Summary of OUL Findings as Public Comment for the Section 404 Clean Water Act Permit
Application by Missouri American Water Company for the Proposed Joplin Reservoir

Dave Woods
Senior Project Scientist
and
Trevor Osorno
Director and Senior Hydrogeologist
Ozark Underground Laboratory, Inc.

3/20/2025

Figure 1. Location of proposed reservoir footprint, losing stream segments, and Lake Springs Complex.

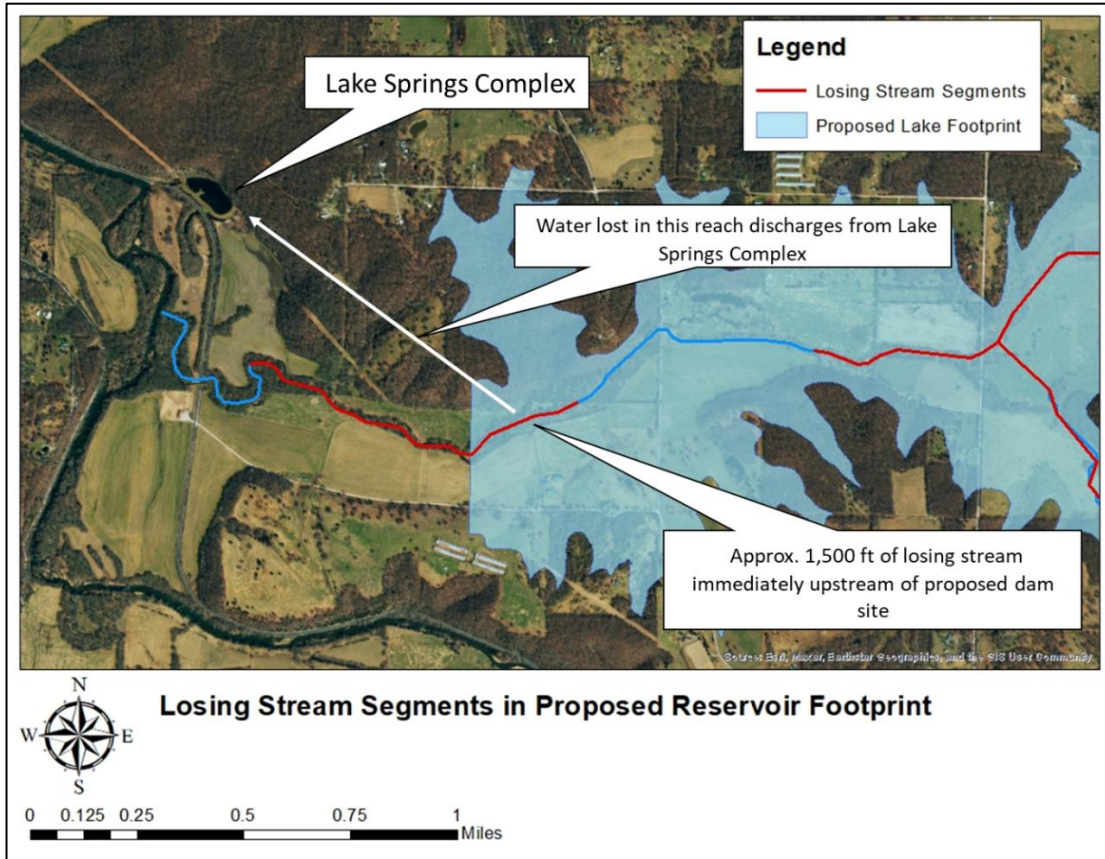
- **The proposed reservoir will experience substantial leakage that is not addressed in MAWC's Section 404 permit public notice documents.**
 - OUL identified three major losing stream segments within the planned reservoir area using fluorescent tracer dyes. All three losing stream segments yielded their respective tracer dye to the Lake Springs Complex. This spring complex is outside of the area that would be impounded by the planned reservoir. The planned dam location will not intercept water leaking out of the proposed reservoir area and into the Lake Springs Complex. **The dye tracing investigations demonstrated that the planned reservoir would experience major water leakage that will discharge outside of the impounded area.**

Figure 2. Map showing features of the Lake Spring Complex and associated wetland.

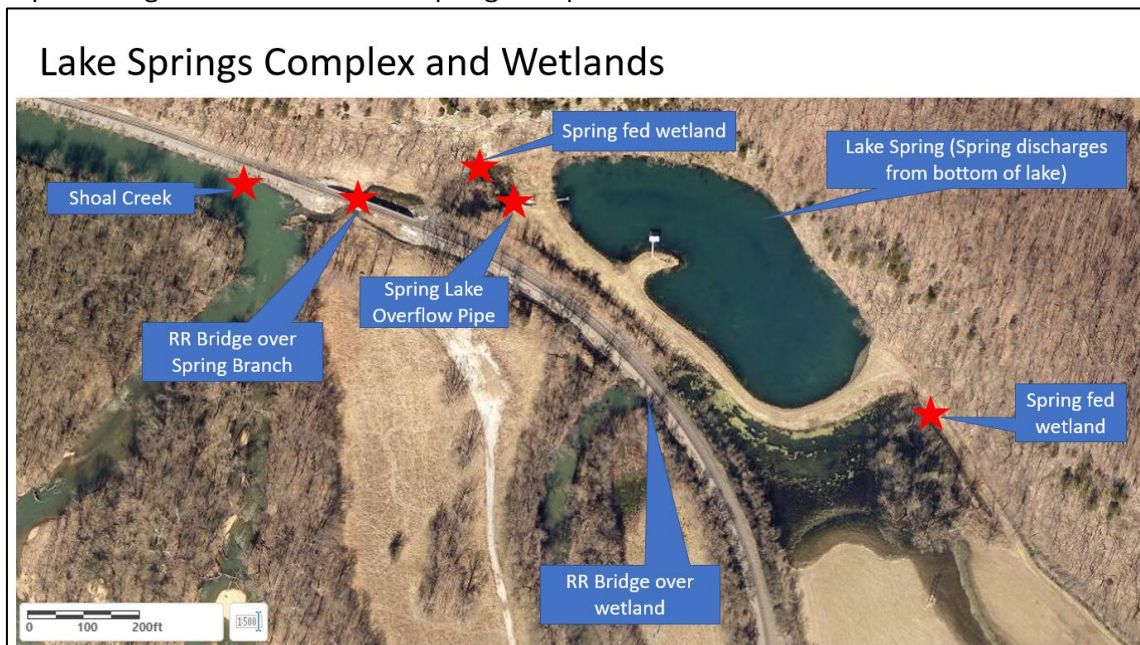
- There are wetlands associated with the Lake Springs Complex that have not been considered in the MAWC Section 404 public notice documents. These wetlands will be affected by discharges resulting from leakage from the proposed reservoir. The current wetlands are fed by springs discharging water from the losing segments of Baynham Branch. **Theoretically, if MAWC can prevent leakage from the planned reservoir, they will be cutting off the water supply to the wetlands.** This will not occur however, since the reservoir will not hold water, but either way **MAWC has not done their due diligence in addressing wetland impacts near the Lake Springs Complex resulting from their proposed actions.**

Figure 3. Flow rate measurements made on November 5th, 2020, showing decreases in flow upstream of the dam site due to the presence of a losing stream segment.

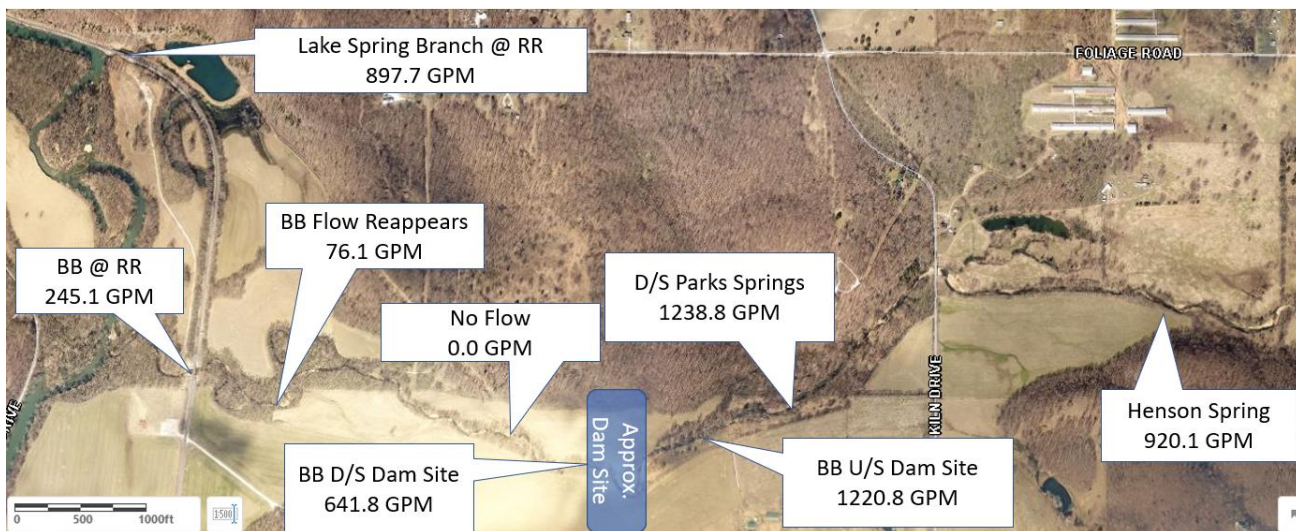
- **The proposed dam design will not prevent leakage.**
 - **Flow rate measurements made on November 5 and 19, 2020 show that water sinking in Baynham Branch between Lime Kiln Road and the railroad accounts for between 90 to 111% of the flow measured at the Lake Springs Complex. Almost all of the flow at the Lake Springs Complex was derived from water sinking in Baynham Branch upstream of the proposed dam site.** Water lost in the stream reaches upstream of the dam site cannot be captured by constructing a seepage barrier under the dam, since the water lost to the groundwater system follows a flow path outside of the Baynham Branch basin to the Lake Springs Complex.

Figure 4. Block diagram of Baynham Branch between Lime Kiln Road and planned dam site under existing natural conditions. The west side of the block is through the dam centerline.

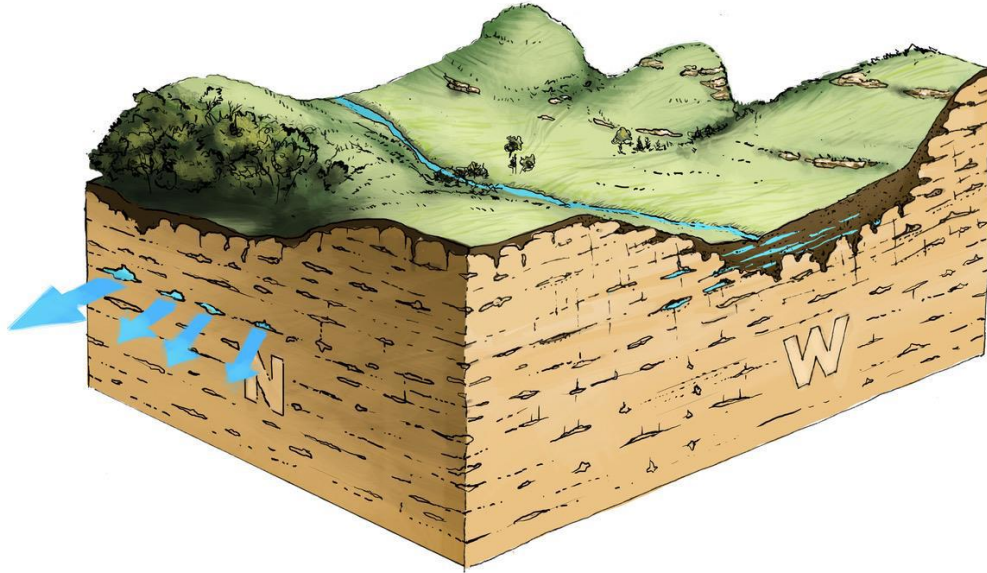
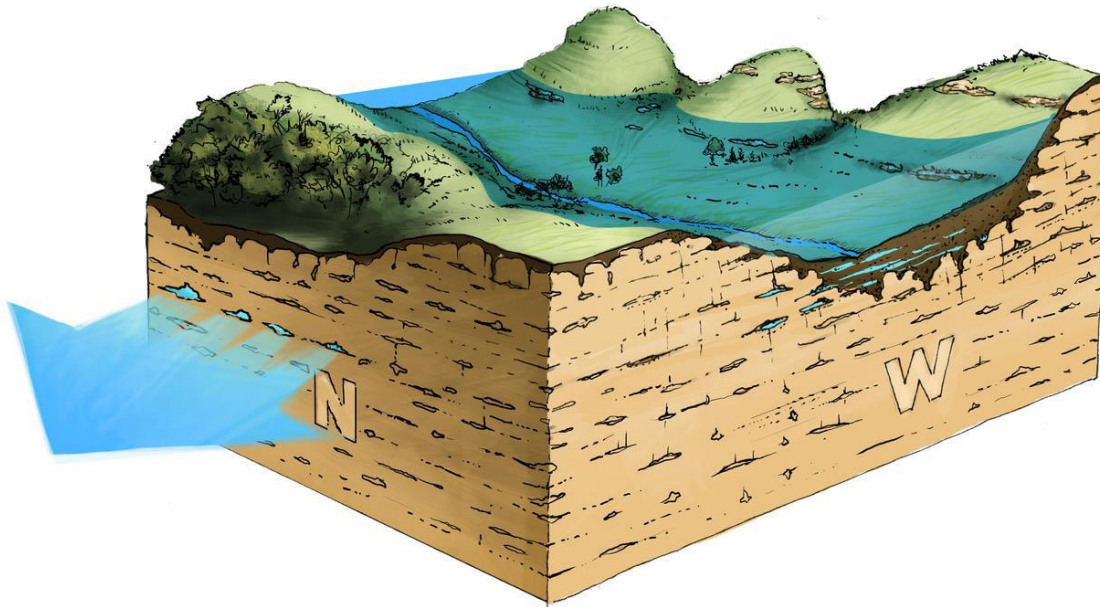
- **The proposed dam on Baynham Branch is within a major losing stream segment.** A major losing stream segment is a highly undesirable location for an earth fill dam intended to impound water to a depth of about 80 feet near the dam site.
